STATE OF NORTH CAROLINA  
DEPARTMENT OF TRANSPORTATION

**Addendum No. 2**

Contract No.: DA00675

*Dare County Rest Area Renovation on US-64 in Manteo, NC*

**A1.2**

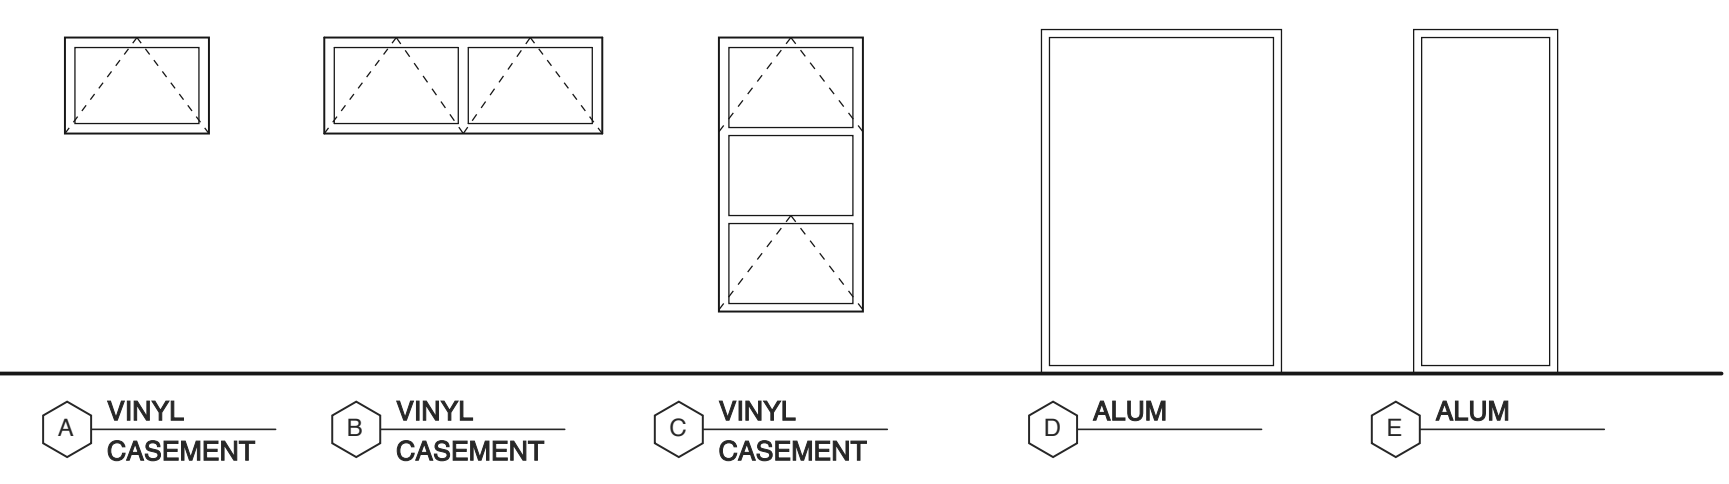
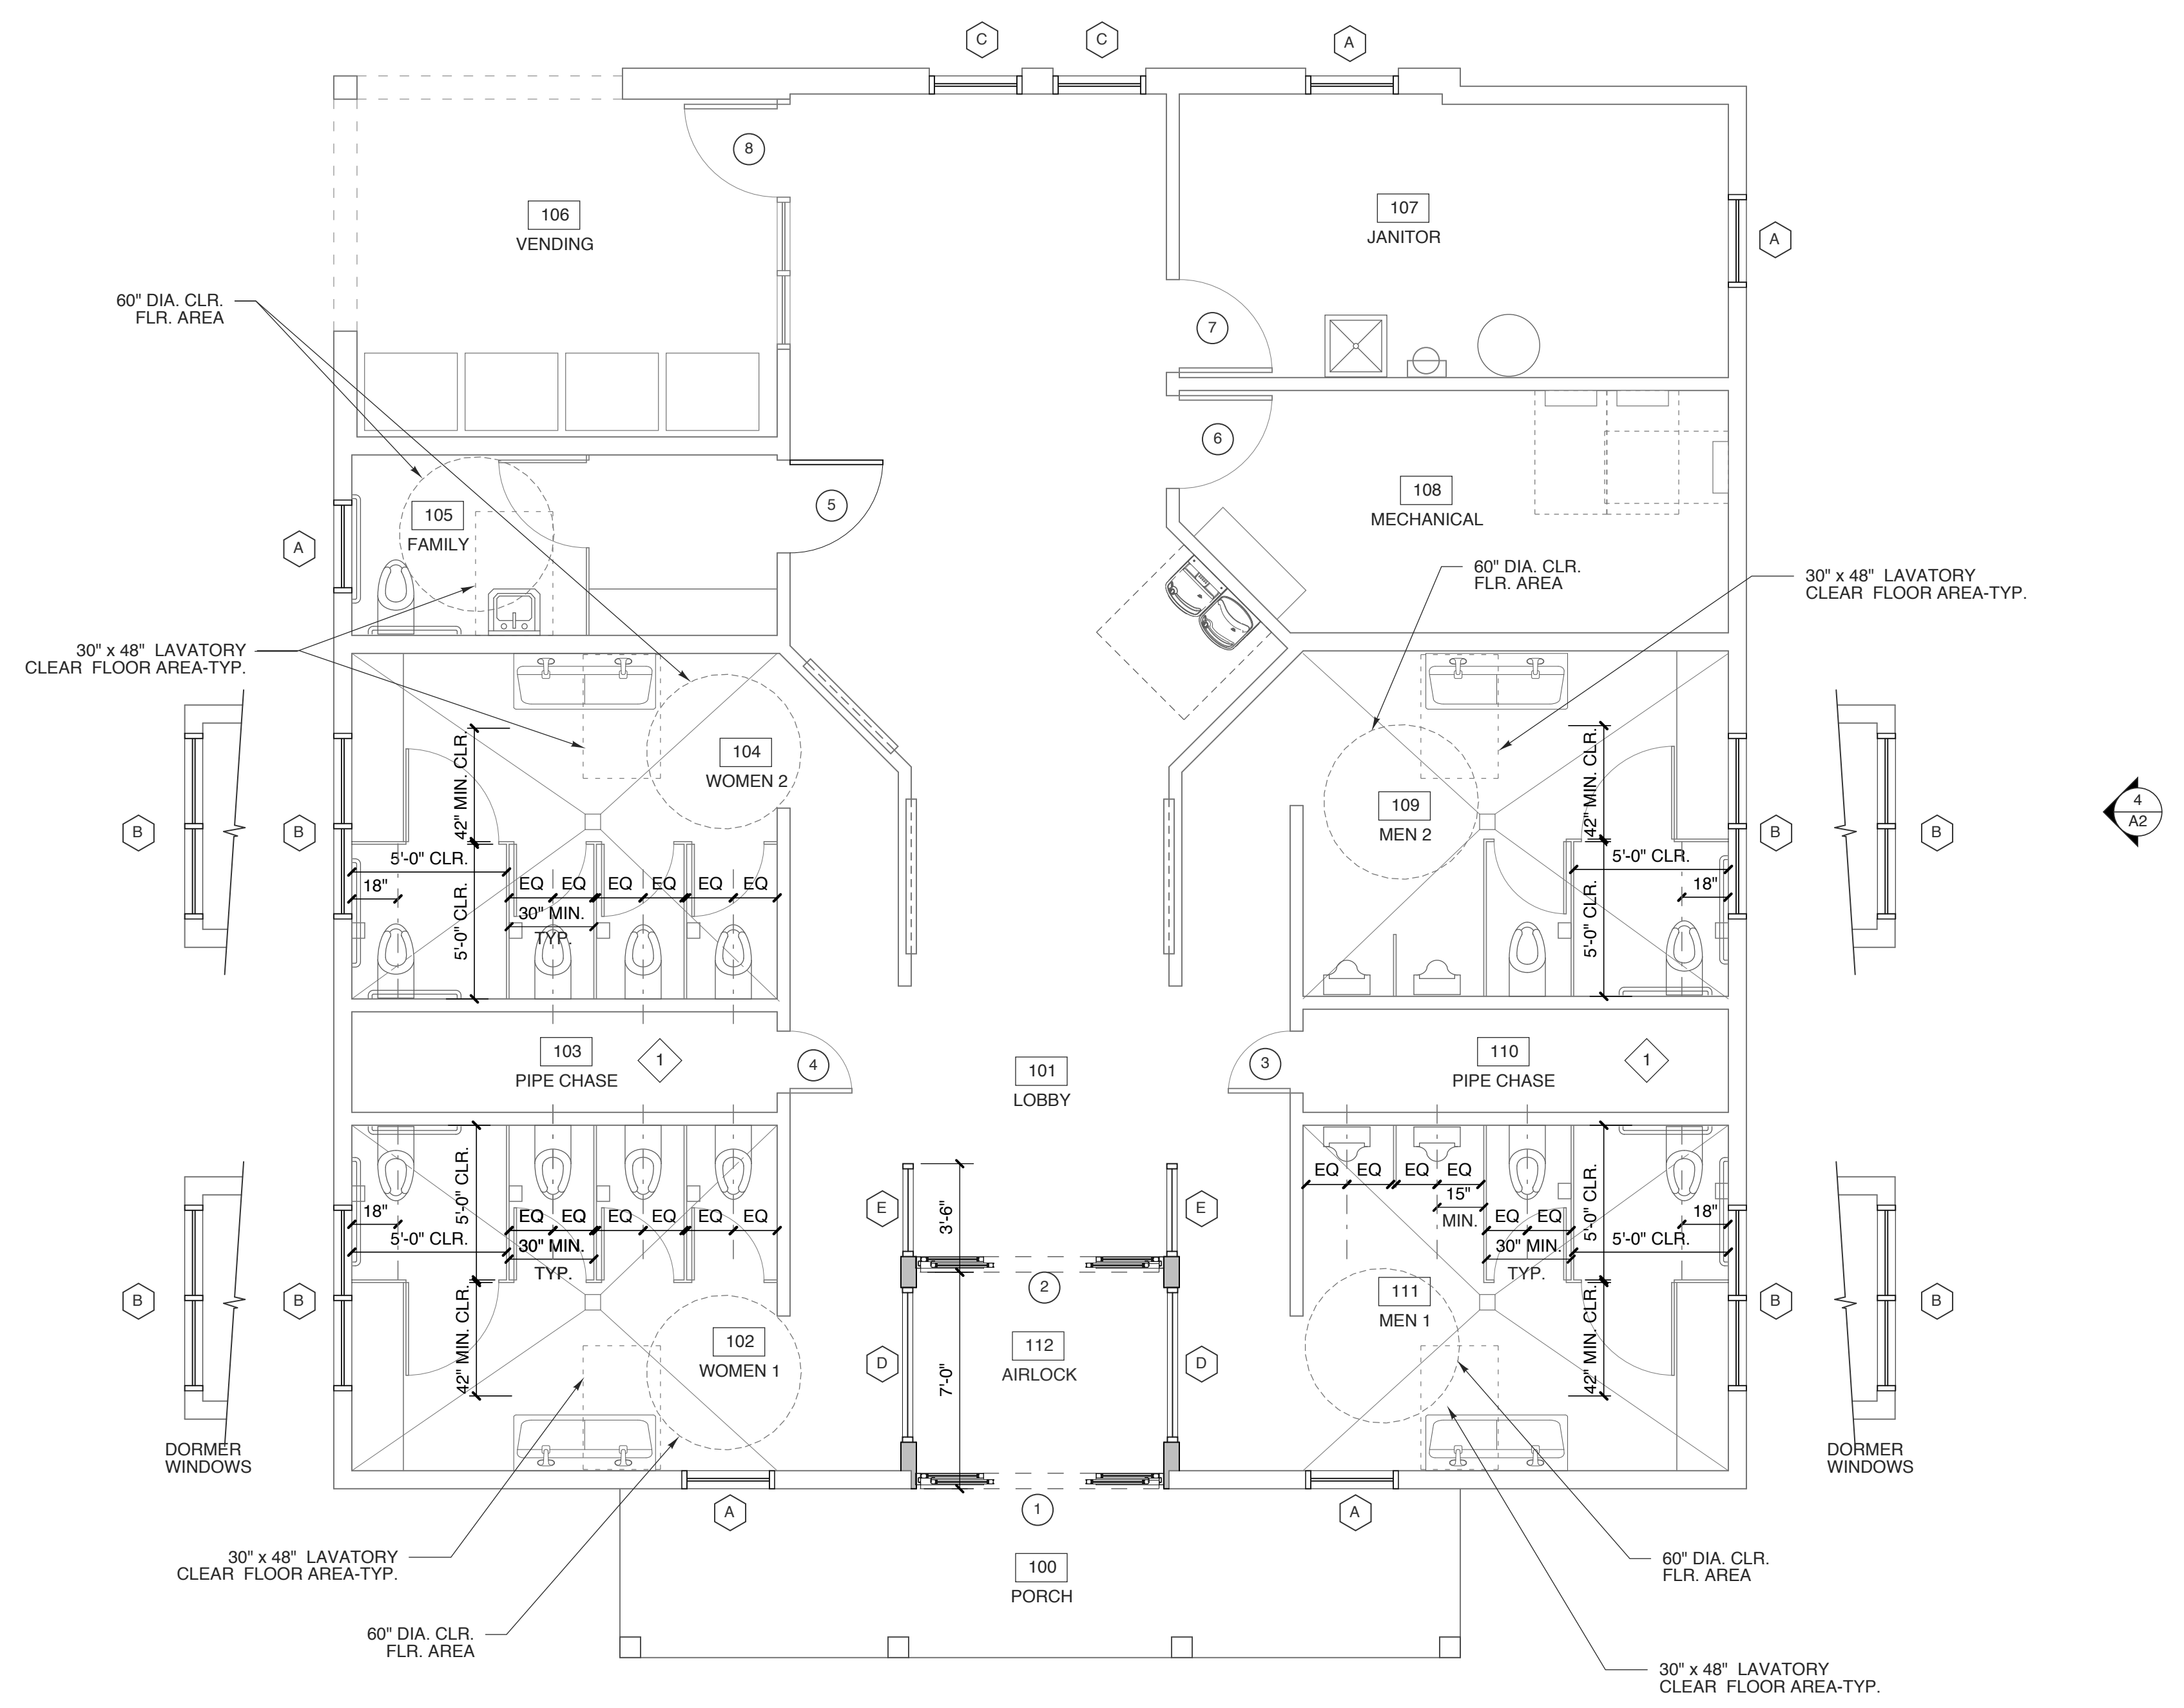
**Plan Sheet A1.2:** The window schedule has been updated to change the dimensions on window marked “D” to be 4’-0” in width instead of 5’-0” to accommodate panel width availability. Please replace the original sheet A1.2 with the attached revised sheet A1.2 dated 10/31/2025.

14) Page A1.2 elevation "D" calls for 5'0" x 7'2" with 3/8" 3Form "Sweep Sliver". The DLO for "D" Elevation will be 56" the Sweep Sliver panels only come in 48" width. Please advise

Window size in Mark "D" changed to 4'-0" x 7'-2", see Addendum 2.

*Answer* - Please revise interim window 'D' to be 4'-0" in width instead of 5'-0" to accommodate panel width availability. **(See attached Sheet A1-2, revised 10/31/2025)**
